ENTERGY	ENGINEERING STANDARD	EN-EP-S-002-MULTI	REV. 0
	Buried Piping and Tanks General Visual Inspection	PAGE 12 OF 12

Piping / Tank IP2 Service Water 24-inch Line INSPECTION DATE: 11/23/11  
409 (WO # 279576-02)

IP2 Service Water Lines 408 & 409 Inspections (Nov. 2011)

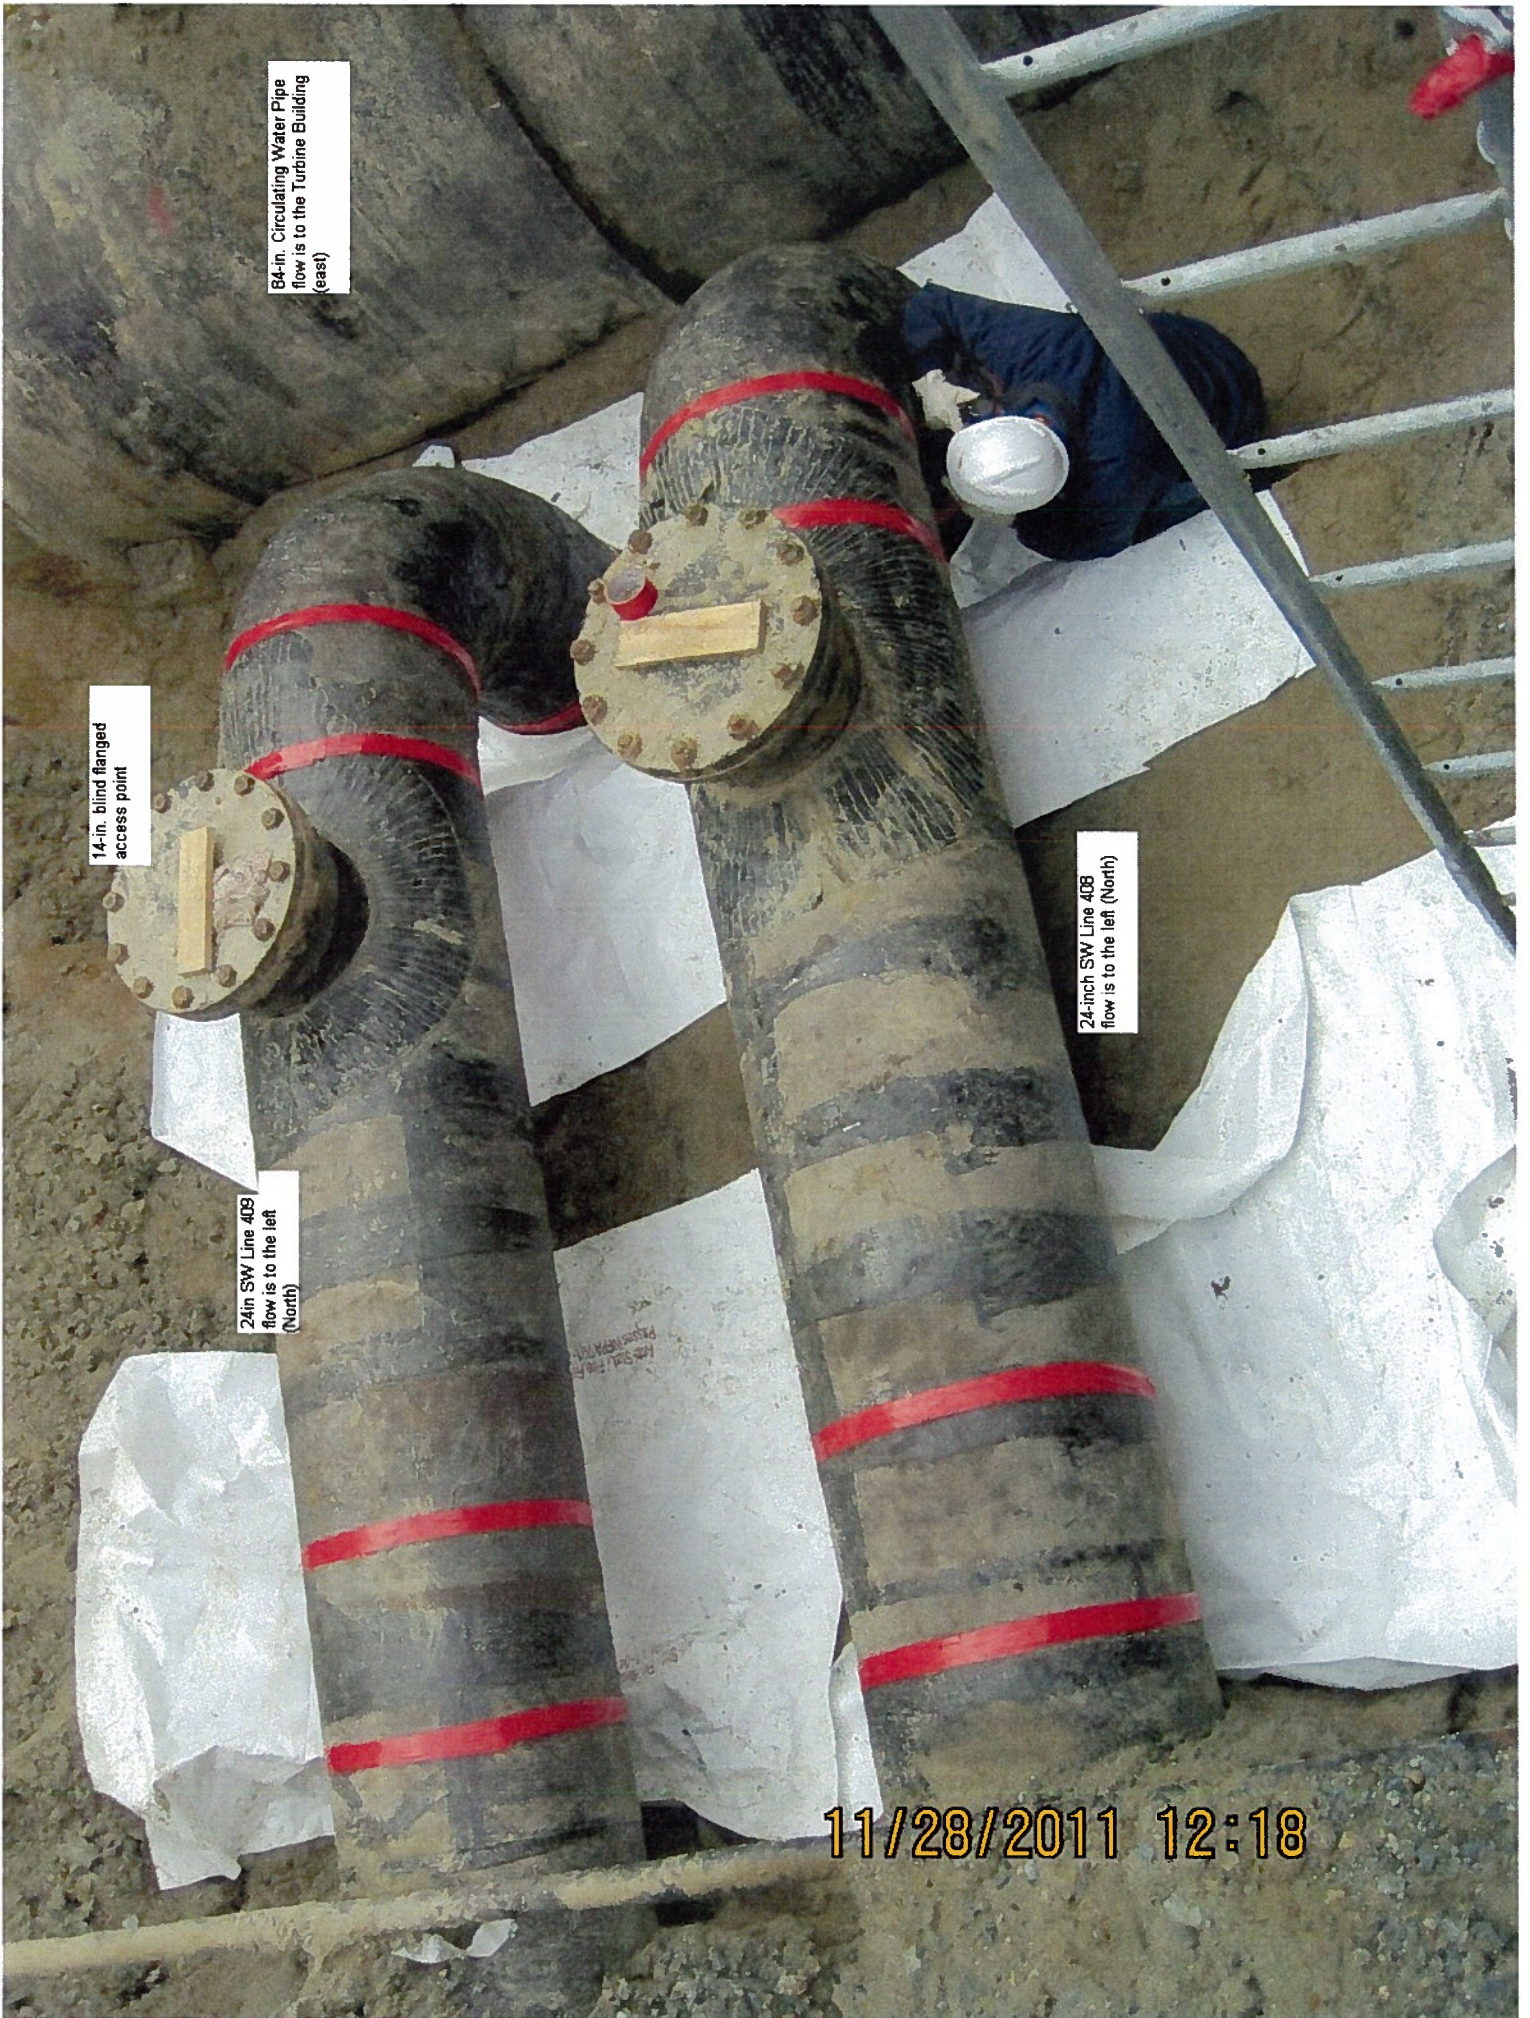
FINE CRACKS IN TOP LAYER OF WRAP ↓
